To: T10 Technical Committee  
 From: Jerry Kachlic, Molex (Jerry.Kachlic@molex.com) and Rob Elliott, HP (elliott@hp.com)  
 Date: 23 December 2004  
 Subject: 05-023r0 SAS-1.1 Connector figures

This adds figures depicting each of the SAS connectors, kindly provided by Molex.

**[Figure 1 — SAS plug connector](#)**

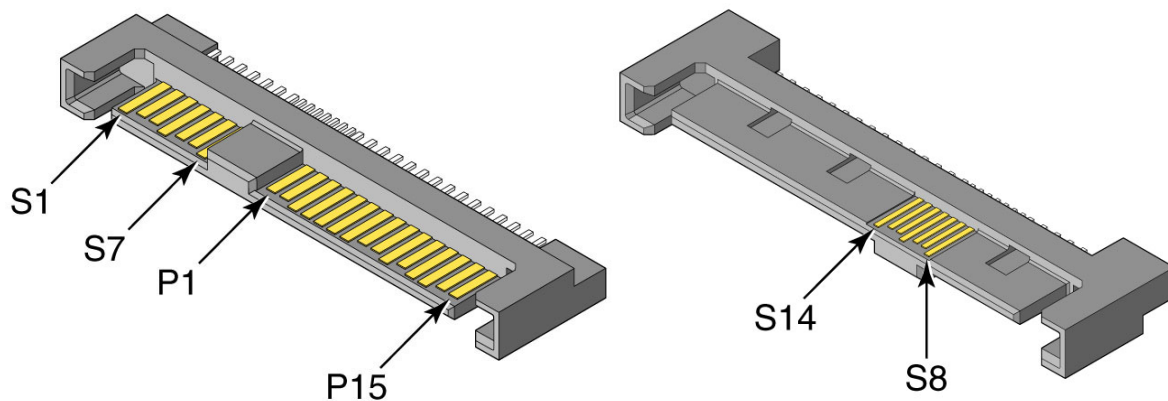
[Figure 1 shows the SAS plug connector.](#)

**[Figure 2 — SAS internal cable receptacle connector](#)**

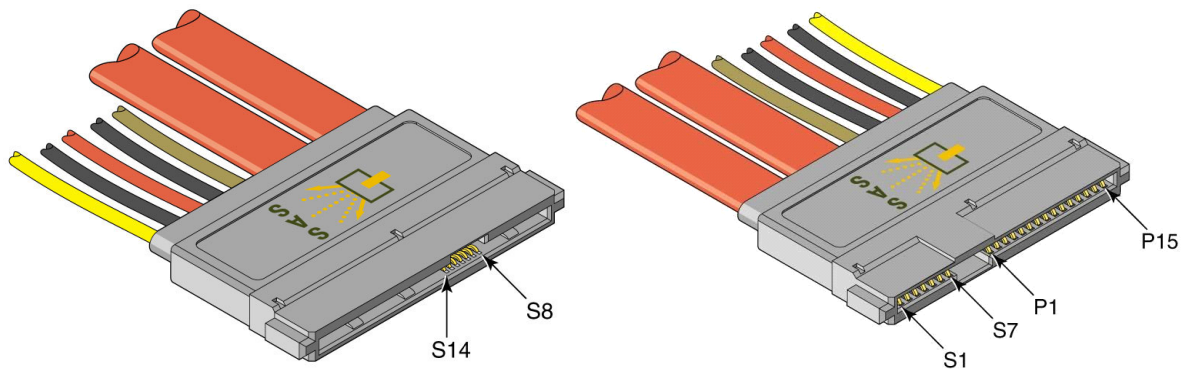
[Figure 2 shows the SAS plug connector.](#)

**[Figure 3 — SAS backplane receptacle connector](#)**

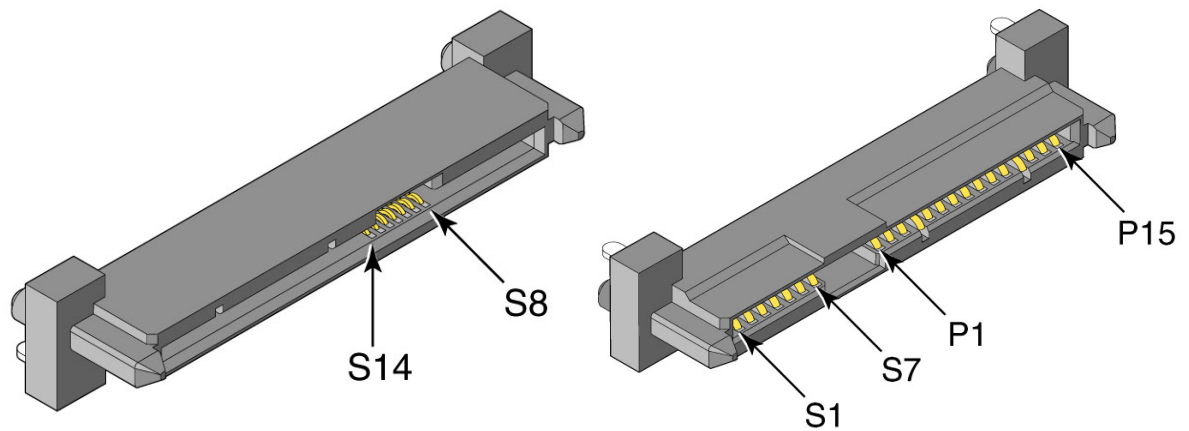
[Figure 3 shows the SAS backplane receptacle connector.](#)

**[Figure 4 — SAS external cable plug connector](#)**

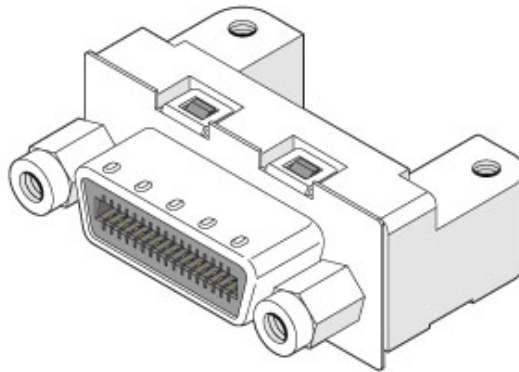
[Figure 4 shows the SAS external cable plug connector.](#)

**[Figure 5 — SAS external receptacle connector](#)**

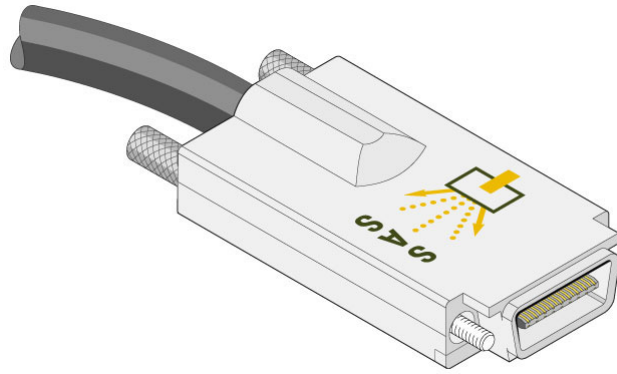
[Figure 5 shows the SAS external receptacle connector.](#)

**[Figure 6 — SAS internal wide plug connector](#)**

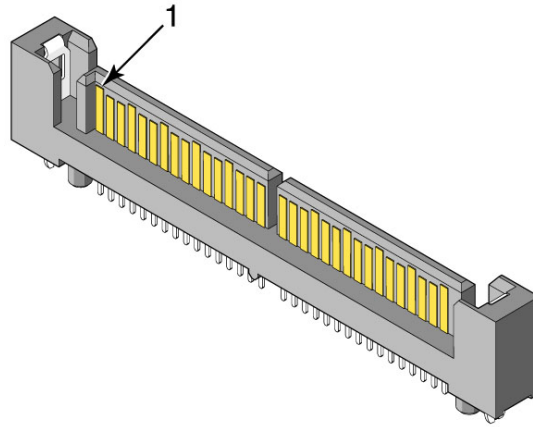
[Figure 6 shows the SAS internal wide plug connector.](#)

**[Figure 7 — SAS internal wide cable receptacle connector](#)**

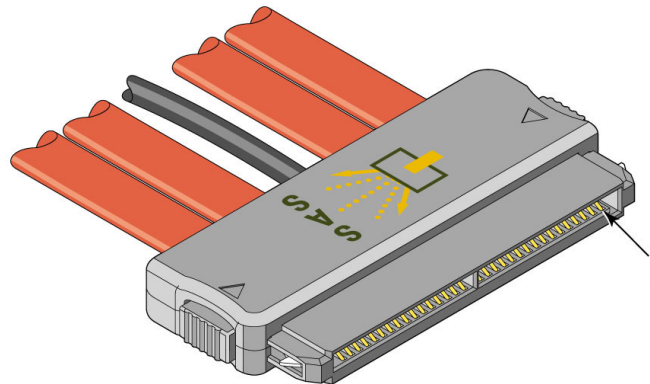
[Figure 7 shows the SAS internal wide cable receptacle connector.](#)
